**BEFORE THE MANAWATU-WANGANUI REGIONAL COUNCIL**

**IN THE MATTER OF** a review of conditions under section 128(1)(a)(iii) and a change of conditions under section 127 of the Act of the Horowhenua District Council's resource consents for discharges at the Levin Landfill

**SECTION 42A REPORT OF DEBORAH RYAN**

**25 August 2016**

**Figure 1 Landfill location, stages and odour sources (MWH, 2015)**

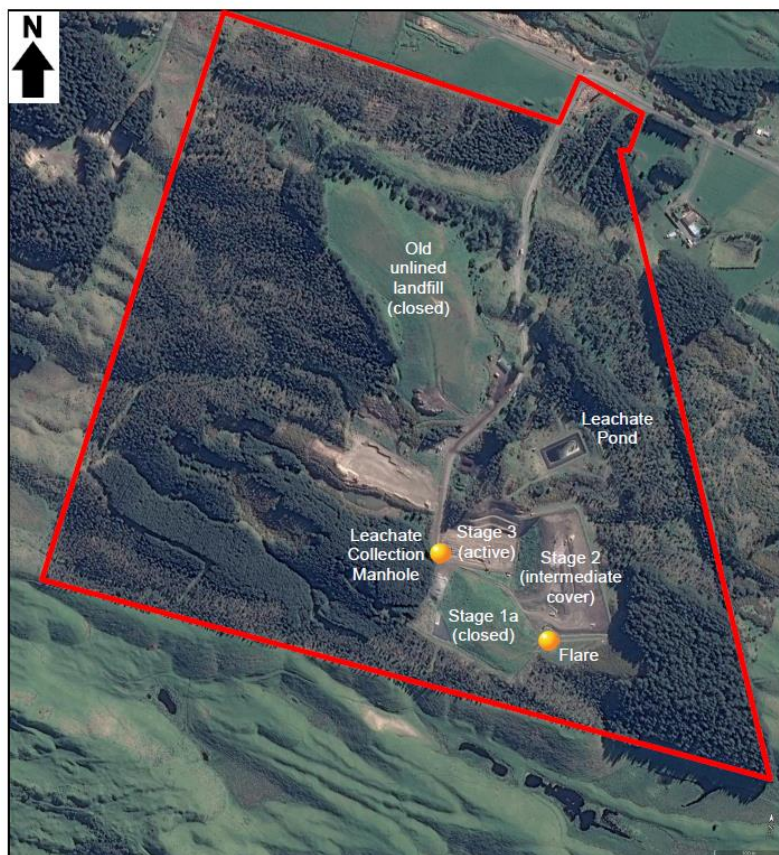
- 13 Figure 1 below, taken from the MWH Report (Figure 1-4) is an aerial photo that shows the nearest residence to the landfill site, which is at 645 Hokio Beach Road (The Grange's property). The residence is approximately 300 metres northeast of the landfill's leachate pond and 500 metres northeast of stage 3 and 400 metres north-northeast of stage 2.

- 17 The scope of my report pertains to air discharges from the operative landfill (shown as stages 1, 2 and 3 in Figure 1) and associated leachate and landfill gas (LFG) management activities. I understand there is a separate consent number 106798, which was changed under application APP-2013016220.01 that authorises the discharge of combustion gases from flaring of landfill gas<sup>6</sup>. I understand that the original consent allowed for landfill gas discharges via seepage through the cap. The changed consent required that a flare (replacing a current flare that is not operational) be installed by 1 July 2016. There is no requirement within the consent to operate the flare (see the advice note to Condition 7). The consent relating to air discharges from the flare is outside the scope of this review as notified by Horizons, although in my view addressing LFG is the critical issue for addressing the effects of odour beyond the boundary of the site.
